Technical *data*

Timing belt CT 881 K2/K4 by the example of Ford 1.25 16V/ 1.4 16 V/
1.6 16 V – Various models from 4/97

Fig. 1
Previous pulley design

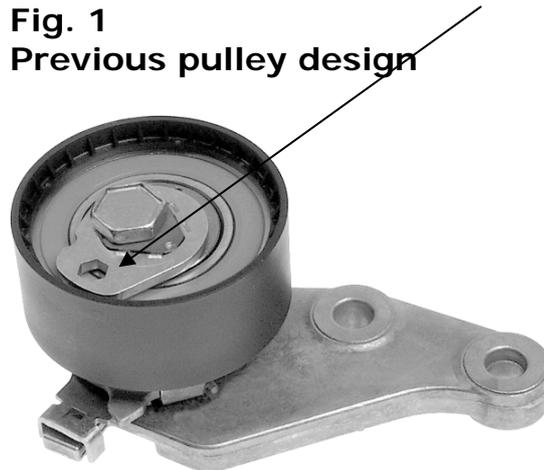
The tension pulley delivered in the kit is designed differently from the pulley previously installed in the vehicle.
(Eccentric adjustment up to pointer alignment using an Allen key)

According to the manufacturer, the new version must be installed instead of the previous one when belts are changed.

The new pulley is now equipped with a pre-mounted cotter pin and can be installed directly. After all components have been installed, the safety cotter pin is just pulled and the tension is set automatically.
